**Written submission from  
David K. Raman**

Application from the CNL to amend its Chalk River Laboratories site licence to authorize the construction of a near surface disposal facility

**Commission Public Hearing  
Part 2**

## **Intervention With Respect to Canadian Nuclear Laboratories' Application to Amend Its Chalk River Laboratories Site Licence to Authorize the Construction of a Near Surface Radioactive Waste Disposal Facility**

**Figure 1 – Defence in Depth Model for NDSF**

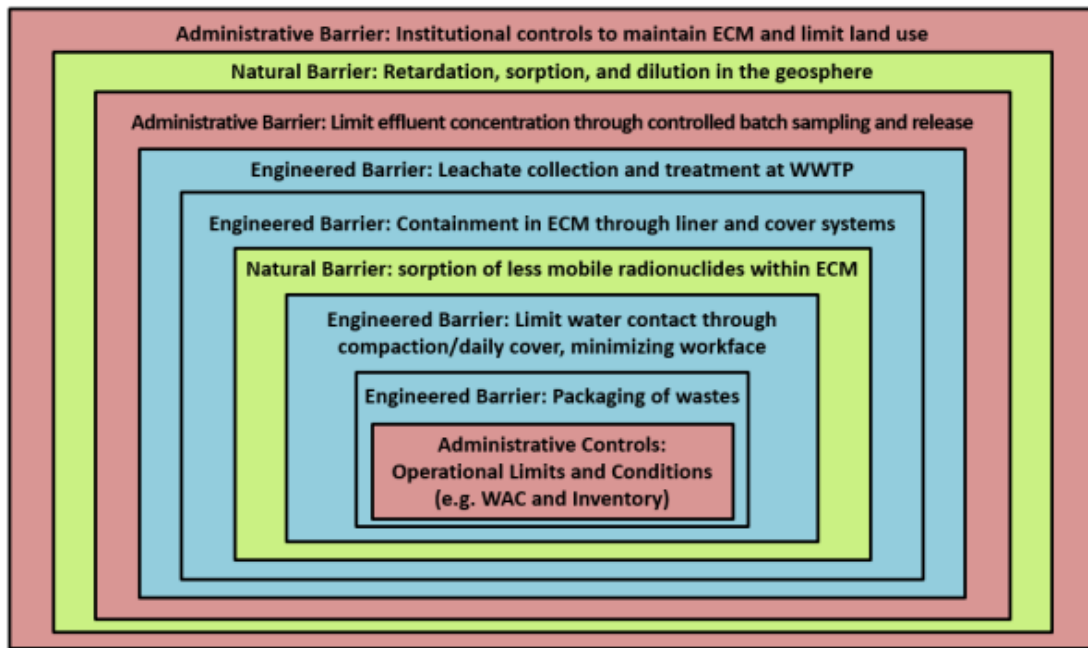
From this figure the “barriers” shown beyond “Containment in ECM through liner and cover systems” are not really barriers at all for the long-term condition. A leachate collection and treatment system is more of a process system that represents a potential leakage route out of containment. The barriers then are:

- The control of the Inventory
- The packaging of the wastes
- The engineered structure.

The barrier missing here is the geological characteristics of the site itself to maintain long-term containment. The following Figure 2, from [2], shows the proposed location for the NDSF; its proximity to surface water does not give great confidence in its geological location as a barrier. To be fair, the Chalk River site itself is problematic for the establishment of any near surface radioactive waste disposal facility; there is simply too much ground and surface water. This need not be a disqualifier for the site. Figure 3 [2] shows the cross-section of the proposed NDSF. For comparison with international experience, Figure 4 shows a proposed Belgian LLW disposal facility at Dessel [3]. It is like facilities at El Cabril in Spain and the Centre de l’Aube in France. What Figure 4 does not show is the location

**Figure 3 – Cross Section of the Proposed NDSF**

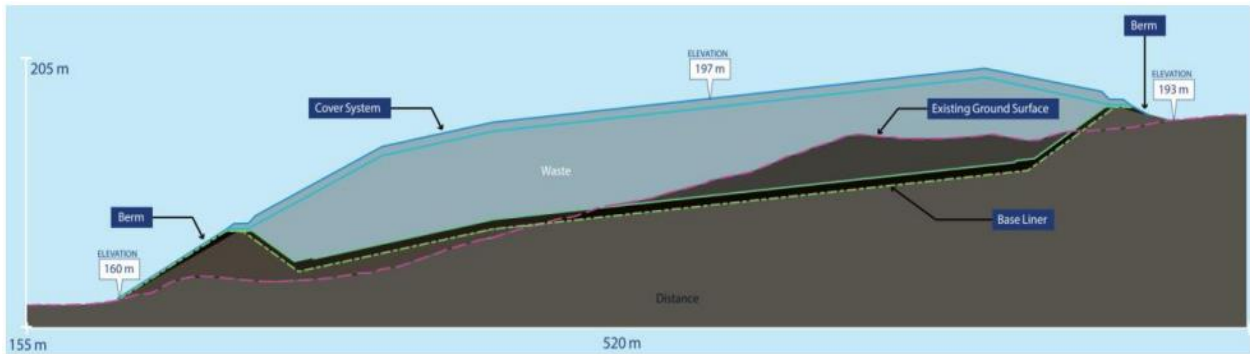
Figure 5 illustrates the cross-section of a near surface facility at Morvilliers, France [4], intended for very low-level radioactive waste, a class considered to be of lesser hazard than LLW, and therefore requiring less rigour in its isolation from the environment. When compared to these European facilities, it can be seen that CNL's NDSF proposal is more in line with a VLLW, not LLW disposal facility.

It can also be seen then that the limitations of proposed site of the NDSF need not disqualify it if the engineered barriers have been hardened beyond what has been proposed.
